Ridgway Town Council
Special Meeting Agenda
Wednesday, August 3, 2022

1. **Application:** Preliminary Plat for Subdivision and Planned Unit Development; **Location:** Town of Ridgway, Block 30, Lots 1-12; **Zone:** Historic Residential (HR); **Applicant:** David Bruce; **Owner:** Ridgway Homes, LLC

To: Town of Ridgway Planning Commission
Cc: Preston Neill, Ridgway Town Manager
From: TJ Dlubac, CPS, Contracted Town Planner
Date: July 29, 2022
Subject: Yellow Brick Lane Sketch Plan and Preliminary Plat for Subdivision and PUD Staff Report for August 3rd Special Town Council Meeting

PRELIMINARY PLAT FOR
YELLOW BRICK TOWNHOMES SUBDIVISION
A PLANNED UNIT DEVELOPMENT
Replat of Lots 1-12, Block 30, Town of Ridgway

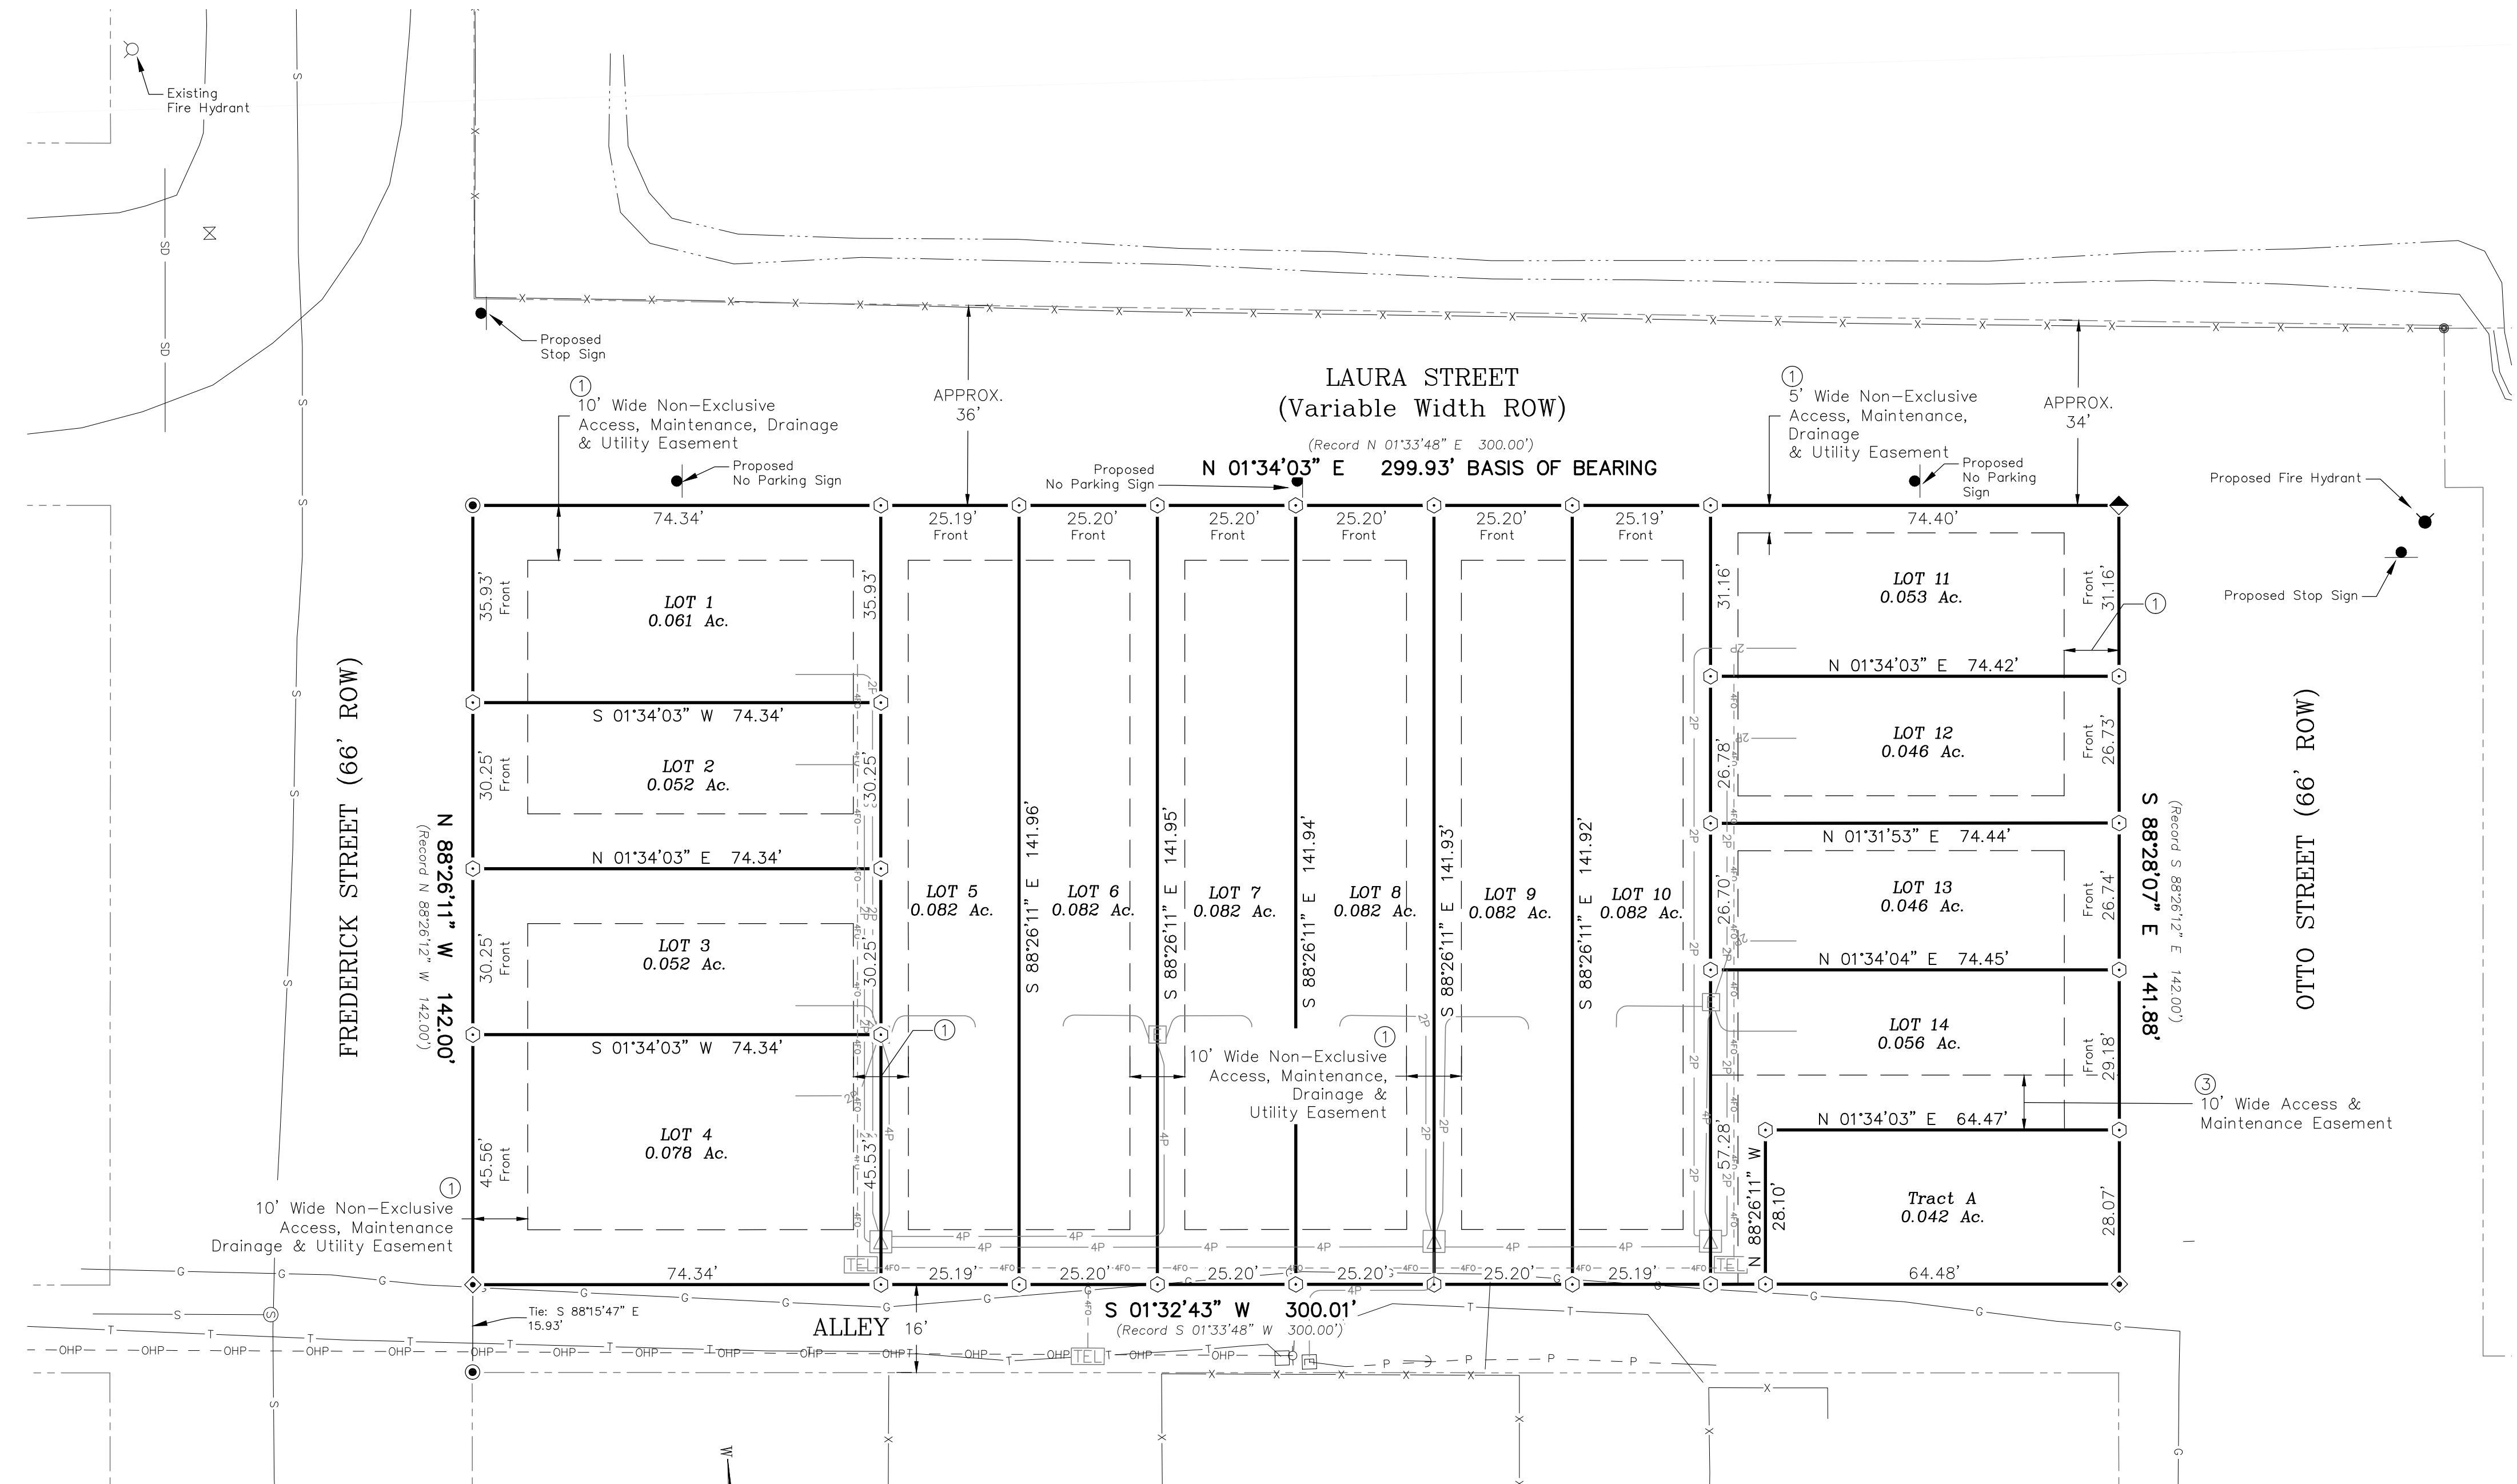
13. Replace the "Approval of Town Attorney" certificate block on sheet 1 of the Preliminary Plat with the following:

14. Replace the "Approval of Planning Commission" certificate block on sheet 1 of the Preliminary Plat with the following:

15. Replace the “Approval of Town Council” certificate block on sheet 1 of the Preliminary Plat with the following:

16. A sample PUD Guide was provided as an attachment to this comment letter for your reference. If a separate PUD Guide is desired, please follow this format. However, if you would like to record only one plan set, the provisions of the PUD Guide shall be added to Sheet 1 of the Preliminary Plat under the header “PUD Guide”.

YBL Plat Prelim	1		Storm		#2 is dedicating Tract A to _____ for storm water. Be sure this blank does not become the Town.	Tract A will be owned and maintained by Ridgway Homes LLC and its dedication has been amended on the Plat.	
YBL Plat Prelim	2		Storm		#3 Be sure the Town is not listed for storm water maintenance. Should add note that filtration media will be required to be replaced if standing water is present after 72hrs.	Note has been added to construction plan sheet SD1.02	Added note.
Civil Plans	5	G3.01 Details	Storm		Orifice plate needs to be removable and provide trash rack to prevent orifice clogging	Note added to Sand Filter Water Quality Treatment Facility detail, sheet G3.01.	Note provided but no change in drawing. Typically trash racks are attached to the outside of the box and the orifice plate to the inside.

G3.01

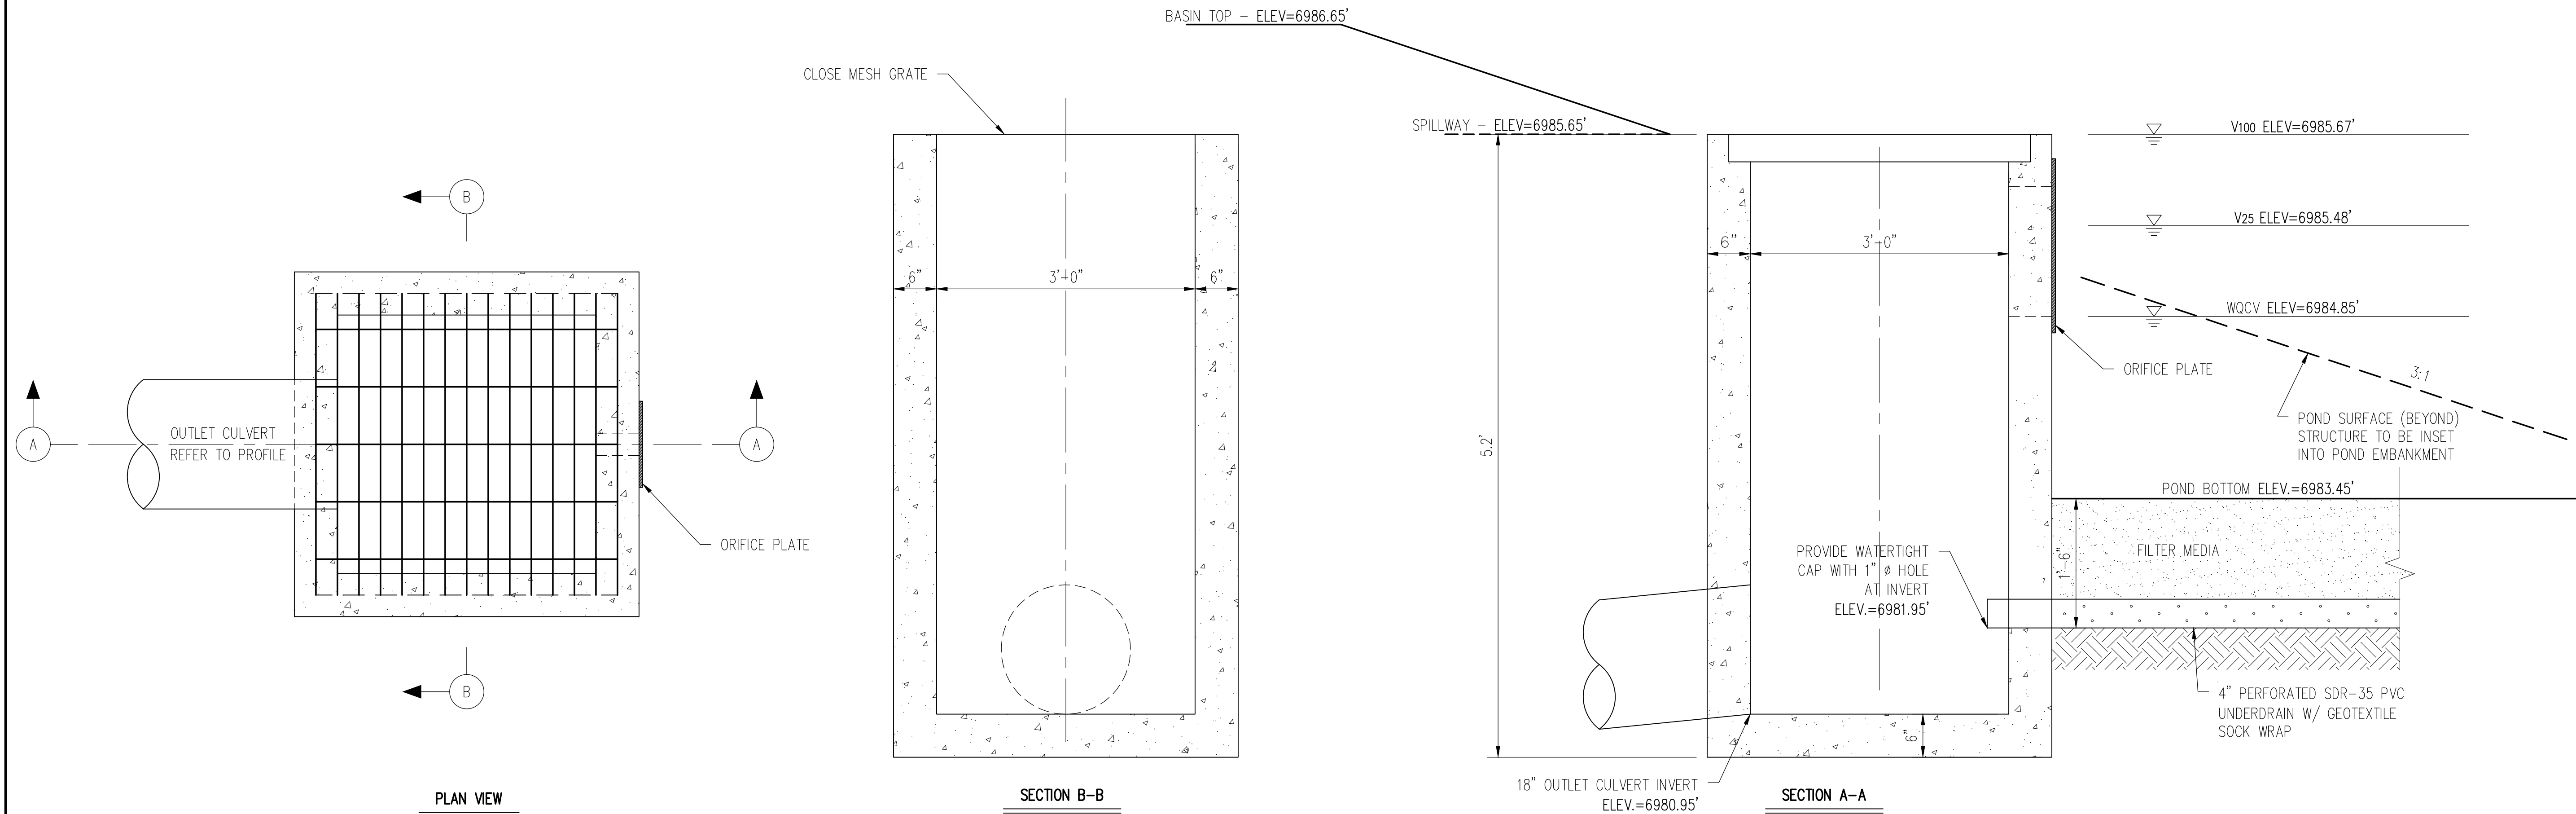
Civil Plans	5	G3.01 Details	Storm					The invert of the emergency overflow needs to be above the 100yr mesh grate. Top of embankment should be at least 1' above emergency overflow. The current 0.04' higher spillway will be difficult to construct and the void space when utilizing riprap with D50=6in will result in overflow before water enters the	Spillway has been changed to concrete.
Civil Plans	5	G3.01 Details	Storm					How long and where does the underdrain go? No cleanout is shown. No sock needed when using CDOT Class C filter	Note added to Sand Filter Water Quality Treatment Facility detail, sheet G3.01.
Civil Plans	5	G3.01 Details	Storm					Riprap depth should be at least twice the D50 and noted to be angular. D50 should be properly bedded not on top of textile. Refer to p. 28 SW Standards	Note added to both Spillway Section and Rundown Section details, sheet G3.01.
Civil Plans	9	RD0.01	Storm					How does water split at Lots 10, 12 and 13 corner? How is runoff from Lots 11, 12, and 13 getting to the treatment basin?	Drainage flow paths have been revised for clariry re: Lot Lot 10. Drainage swale has been added to address Lot 11-14 runoff.

Document	Pg	Sht Name	Detail	Goff Comments	Town 070122	Goff Comments	
Civil Plans	5	G3.01 Details	Storm		#4 filter material should be CDOT Class C filter material.	Note added to Sand Filter Water Quality Treatment Facility detail, sheet G3.01.	Const Note 4 calls out concrete sand, crusher fine or as approved by engineer. That does not seem consistent with Class C in cdot table 703-10
Civil Plans	5	G3.01 Details	Storm		The invert of the emergency overflow needs to be above the 100yr mesh grate. Top of embankment should be at least 1' above emergency overflow. The current 0.04' higher spillway will be difficult to construct and the void space when utilizing riprap with D50=6in will result in overflow before water enters the designed outlet.		Changed to concrete.
Civil Plans	5	G3.01 Details	Storm		How long and where does the underdrain go? No cleanout is shown. No sock needed when using CDOT Class C filter material	Note added to Sand Filter Water Quality Treatment Facility detail, sheet G3.01.	No note on G3.01 regarding underdraing length or describing cleanout.

Civil Plans	5	G3.01 Details	Storm		Riprap depth should be at least twice the D50 and noted to be angular. D50 should be properly bedded not on top of textile. Refer to p 28 SW Standards	Note added to both Spillway Section and Rundown Section details, sheet G3.01.	Added to rundown
Civil Plans	9	RD0.01	Storm		How does water split at Lots 10, 12 and 13 corner? How is runoff from Lots 11, 12, and 13 getting to the treatment basin?	Drainage flow paths have been revised for clarity re: Lot Lot 10. Drainage swale has been added to address Lot 11-14 runoff.	OK
Civil Plans	9	RD0.01	Storm		Driveways for lots 2 and 3 are in runoff flow paths. Anything to insure they don't obstruct the flow? Is water going N or E along Lot 3?	Refer to Overlot grading plan sheet RD0.01 which conveys storm water across gravel driveway. The CCR's for the subdivision specify that drainage conveyances must be maintained.	Believe the O&M responsibilities should be a plat note.

Sheet
G3.03

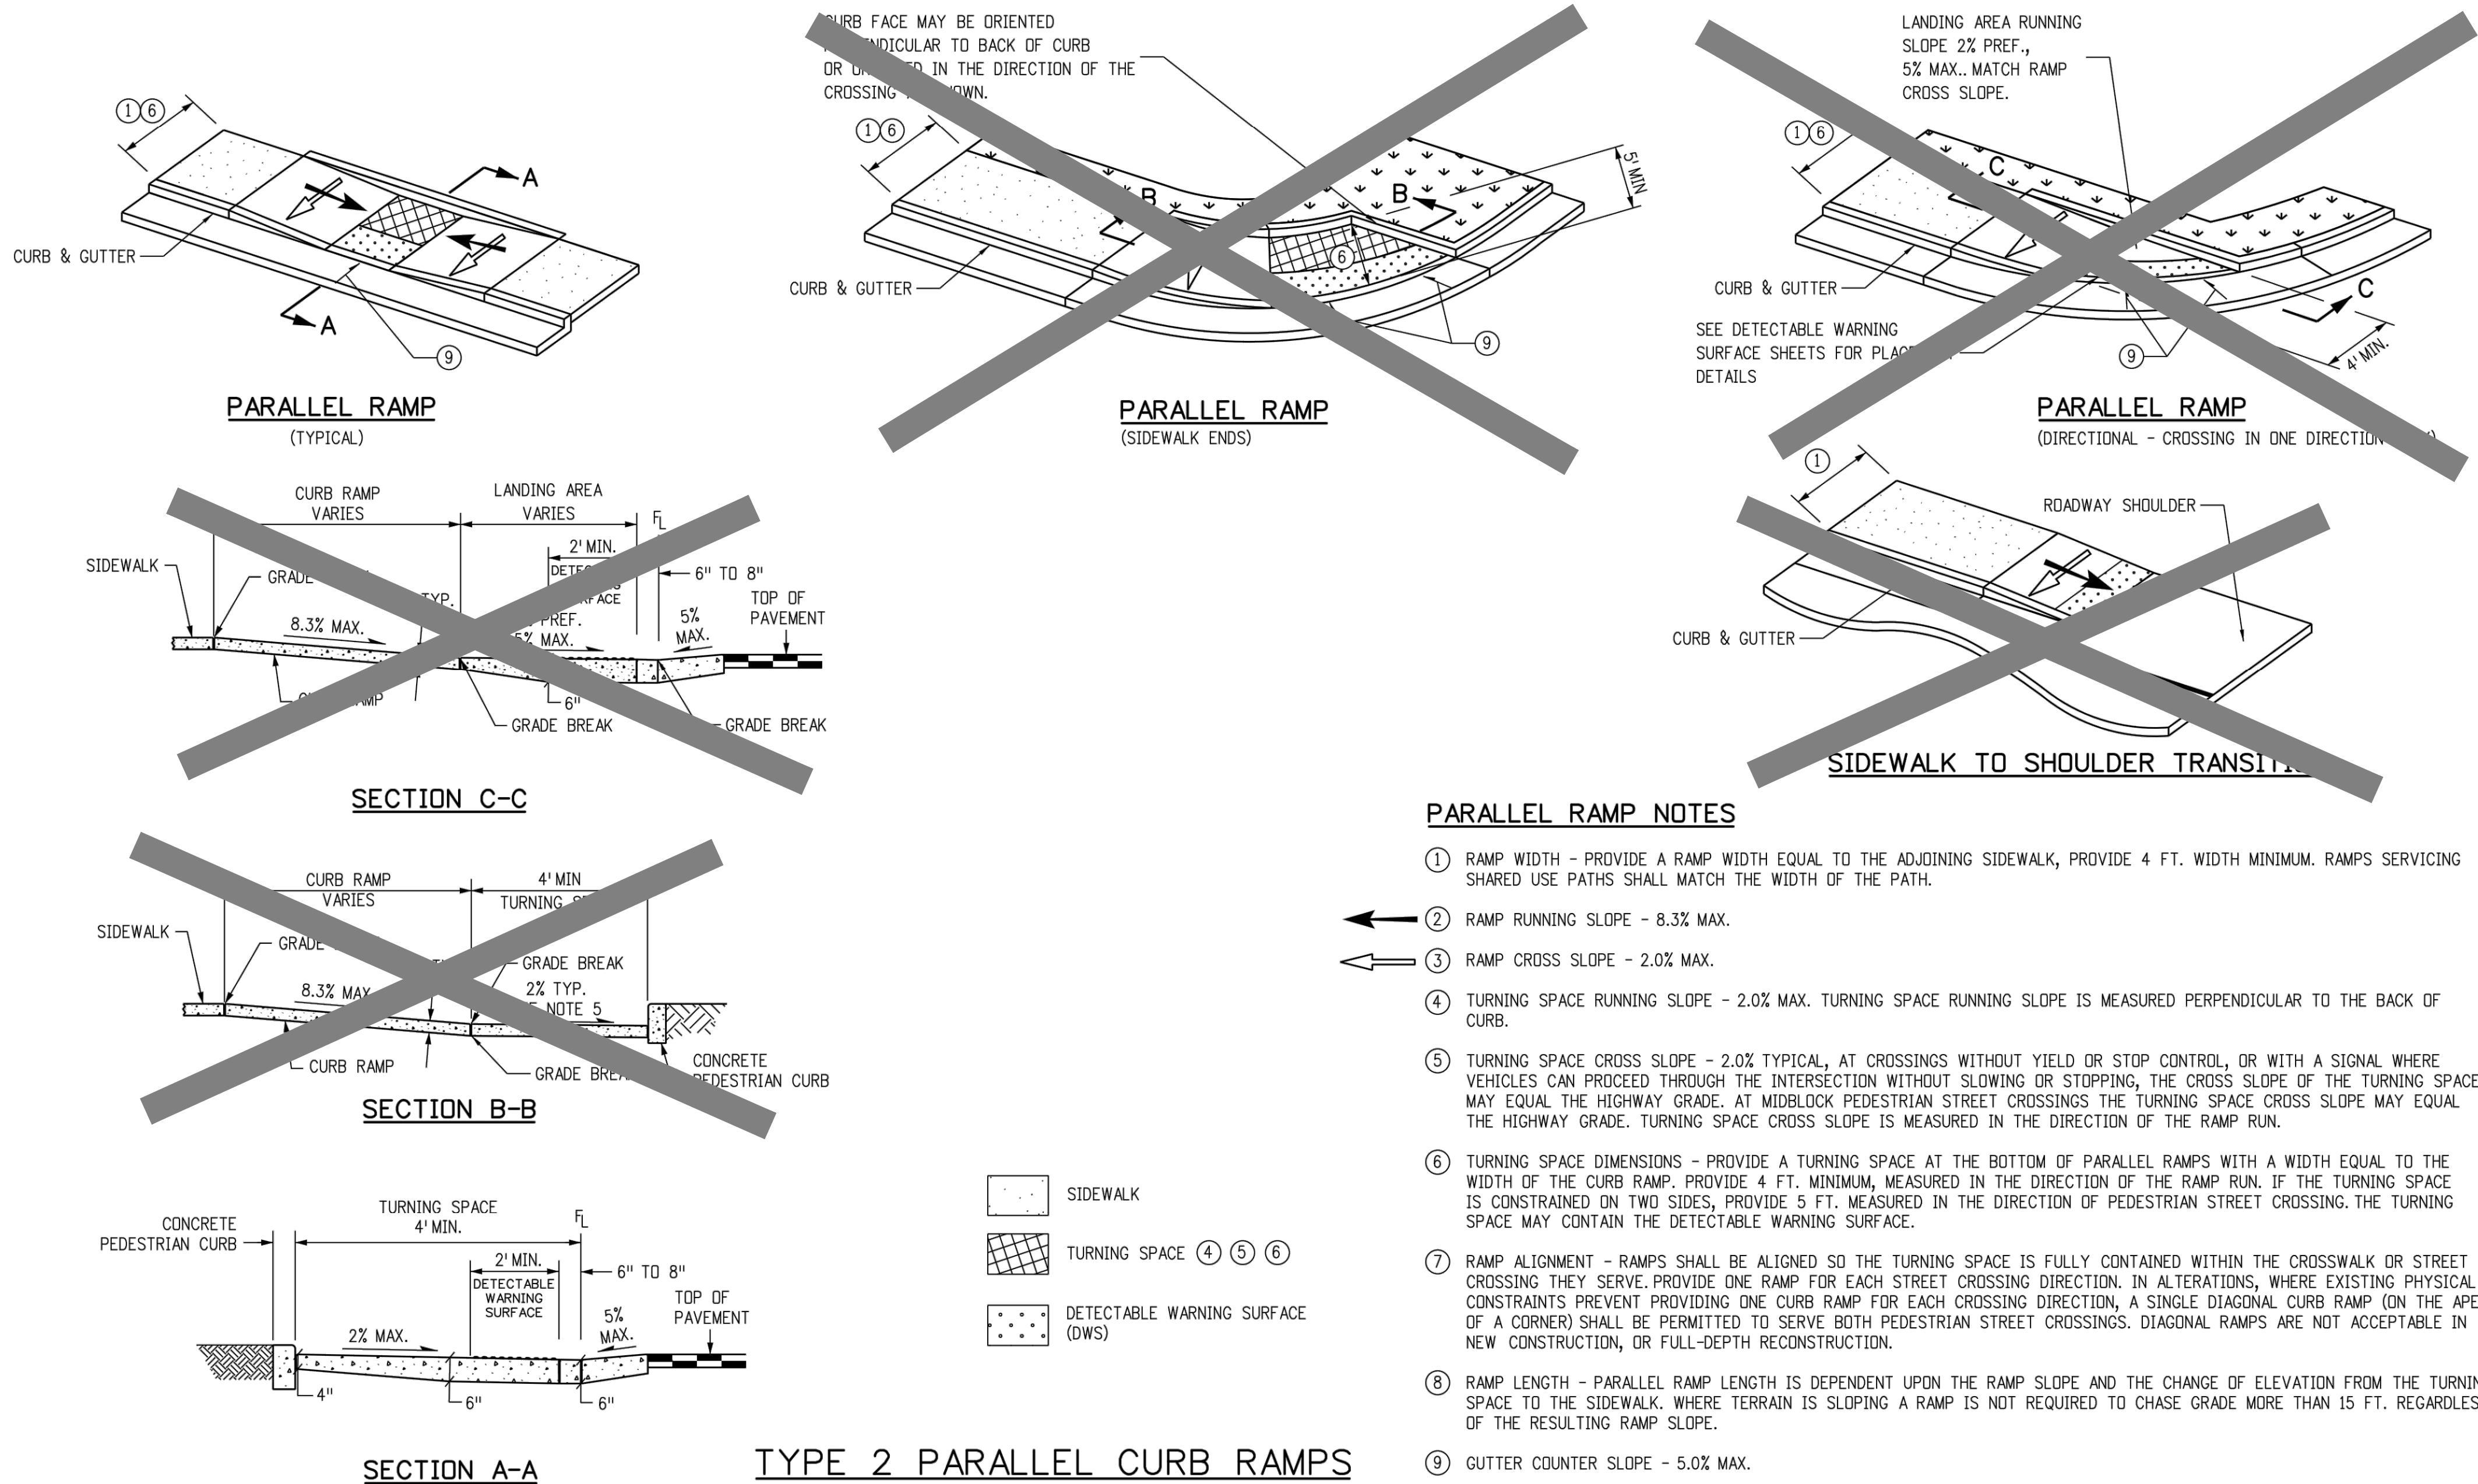
Civil Plans	10	Otto P&P & others	Curb Ramps	Where are the curb ramp details. Is there enough platform behind the detectable warning to meet ADA?	Curb ramp has been designed per CDOT standards. CDOT details has been added sheet G3.03 Details (3).	added	N/A		N/A
Civil Plans	10	Otto P&P & others	Water	The Town prohibits concrete encasements of water and sewer lines. Please comply with the Town typical encasement detail	Thew word 'concrete" has been removed from 20' encasement callouts.	Not seeing any encasements now.	Utilities has been revised, eliminated need for concrete encasements.	OK	N/A
	12	Otto P&P	Water					Looks like there is only one foot separation from bottom of storm pipe and top of water line. That will require insulation	Callout for insulation and casing is located on sheet W1.03. Waterline Profile Sheets have been previously added for clarity.
	12	Otto P&P	Storm					Why is a sidewalk drain box needed near station 1+65	Sidewalk Chase Drain is no longer needed due to revised inverted crown alley cross section.
